Project	IEEE 802.16 Broadband Wireless Access Working Group < http://ieee802.org/16 >	
Title	Residual Termination Block Processing with CTS	
Date Submitted	2005-07-14	
Source(s)	Zhengfei Xiao, Yongmao Li, Phillip Barber, Jim Carlo, David Xiang, Duke Dang, Lucy Chen, John Lee	mailto:john_lee@huawei.com
	HUAWEI	
	Seokheon Cho	
	Sungcheol Chang	
	Chulsik Yoon	
	ETRI	
Re:	Call for contribution and comments.	
Abstract	Residual Termination Block Processing with CTS.	
Purpose	Adoption	
Notice	This document has been prepared to assist IEEE 802.16. It is offered as a basis for discussion and is not binding on the contributing individual(s) or organization(s). The material in this document is subject to change in form and content after further study. The contributor(s) reserve(s) the right to add, amend or withdraw material contained herein.	
Release	The contributor grants a free, irrevocable license to the IEEE to incorporate material contained in this contribution, and any modifications thereof, in the creation of an IEEE Standards publication; to copyright in the IEEE's name any IEEE Standards publication even though it may include portions of this contribution; and at the IEEE's sole dis

Figure 137d—Residual termination block processing with CTS

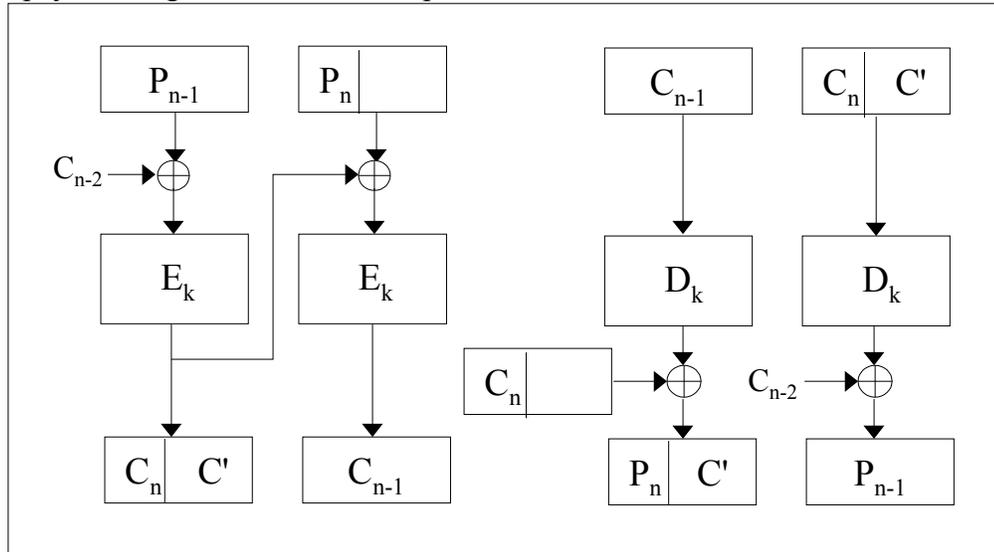
Per D9 in section 7.8.4.2, if the final block size n is smaller than cipher block size, the next-to-last ciphertext block shall be AES encrypted for the second time, using the electronic code book (ECB) mode, and the most significant n bits of the result are XORed with the final n bits of the payload to generate the short final cipher block. There are two problem about the method .One is that the method has been proved not secure enough, though it was often used. Since the final block is not encrypted but XORed with a block, any modified bits can just affect the corresponding bits which means that the malicious attacker can easily predict the modification results. If the termination block does not contain important information, it may not matter much. However, if the termination block contains important information, it would be a serious security problem. The other is this mechanism requires the receiver supporting encryption algorithm in both ECB and CBC mode.

Introduce the CTS mechanism to process the termination block with AES CBC mode. Using this residual termination block processing rule, all of the blocks are encrypted with AES. Further, the sender and receiver will encrypt and decrypt data only in CBC mode in most cases. Both of the sender and receiver need not support encryption or decryption in ECB mode.

~~Residual termination block processing shall be used to encrypt the final block of plaintext when the final block is less than the cipher block size. Given a final block having n bits, where n is less than the cipher block size, the next-to-last ciphertext block shall be AES encrypted for the second time, using the electronic code book (ECB) mode, and the most significant n bits of the result are XORed with the final n bits of the payload to generate the short final cipher block. In order for the receiver to decrypt the short final cipher block, the receiver AES encrypts the next-to-last ciphertext block, using the ECB mode, and XORs the most significant n bits with the short final cipher block in order to recover the short final plaintext block. This encryption procedure is depicted in Figure 9.4 of Schneier [B42].~~

Residual termination block processing shall be used to encrypt the final block of plaintext when the final block is less than the cipher block size. Given a final block having n bits, where n is less than the cipher block size m , the next-to-last ciphertext block shall be divided into two parts. One of the two parts is n bits, the other part is $m-n$ bits. The former will be sent to receiver as the final block ciphertext. Padding the final short block to obtain a complete plaintext block, then encrypt it with AES algorithm in CBC mode. The encryption and decryption procedure is depicted in Figure 137d.
